#### **Addendum 128 – UN Regulation No. 129**

#### **Revision 3 - Amendment 4**

Supplement 5 to the 02 series of amendments – Date of entry into force: 11 January 2020

#### **Uniform provisions concerning the approval of Enhanced Child Restraint Systems used on board of motor vehicles**

### Arrangements of the module mark in combination with an approval mark

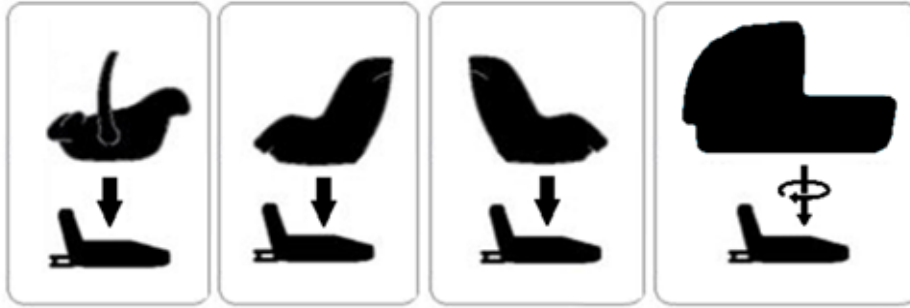
Current examples given to be deleted and replaced by the following:

The Enhanced Child Restraint System module bearing the above module marks is capable of being used in a rearward facing mode with the base "brand name and model name", for the 85 cm–105 cm size range and with a mass limit of 18 kg; approved according to UN Regulation No. 129-02 under the number 022441.

The Enhanced Child Restraint System module bearing the above marks is also capable of being used in a forward facing mode with the base "brand name and model name", for the 85 cm–105 cm size range and with a mass limit of 18 kg; approved according to UN Regulation No. 129-02 under the same number 022441.

The approval number indicates that the approval was granted in accordance with the requirements of the UN Regulation concerning the approval of Enhanced Child Restraint Systems used on-board motor vehicles as amended by the 02 series of amendments.
